**Subject:** RE: 3324.20 Woodside Condo Peer Review **Attachments:** Windham PBR WeldLlc 01032019.pdf;

Subject: 3324.20 Woodside Condo Peer Review

- Final Major Subdivision Application, dated February 4, 2019, prepared by DM ROMA
- Waiver request form
- Woodside Condominium Plan Set, dated February 4, 2019, prepared by DM ROMA
- Peer Review by Jonathan Earle, dated December 3, 2018

### **EXISTING GRADE SKETCH - FILTER BASIN 1**

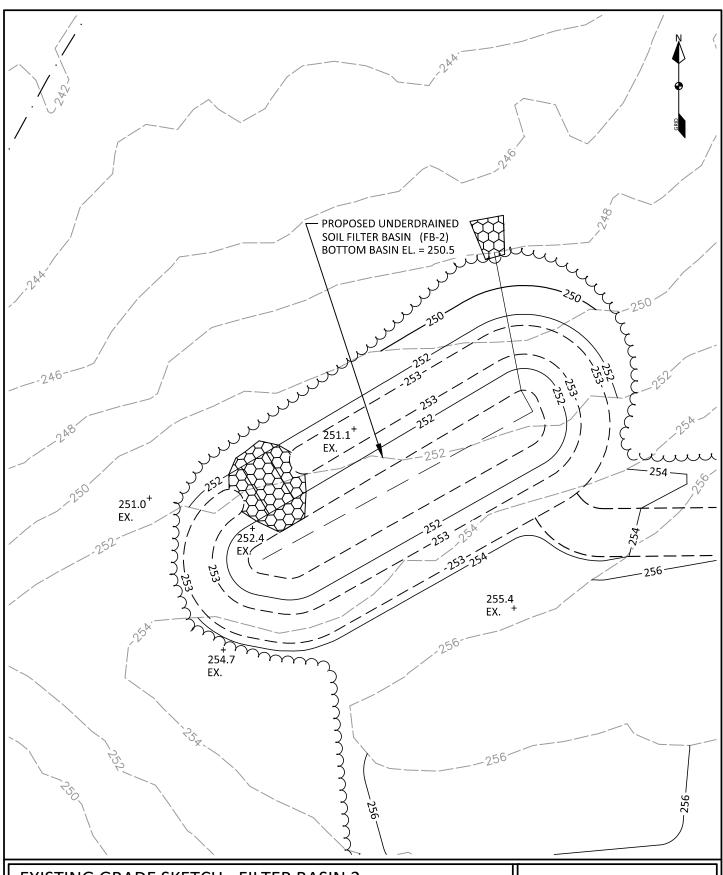
- 9. Revise Stormwater report to include additional impervious area of Major Private Drive as applicable.
- 10. Prior comment from Town Engineer in 12/3/2018 comments requested that ground topography be provided in the stormwater management areas. Has this been completed?

- 9. Not applicable.
- 10. Ground topography in the area of the proposed stormwater filter ponds was performed by Survey, Inc using ground survey methods. The attached two exhibit drawings show that the surveyed ground shots are consistent with the LIDAR survey, so no adjustments to the surface contours are necessary.
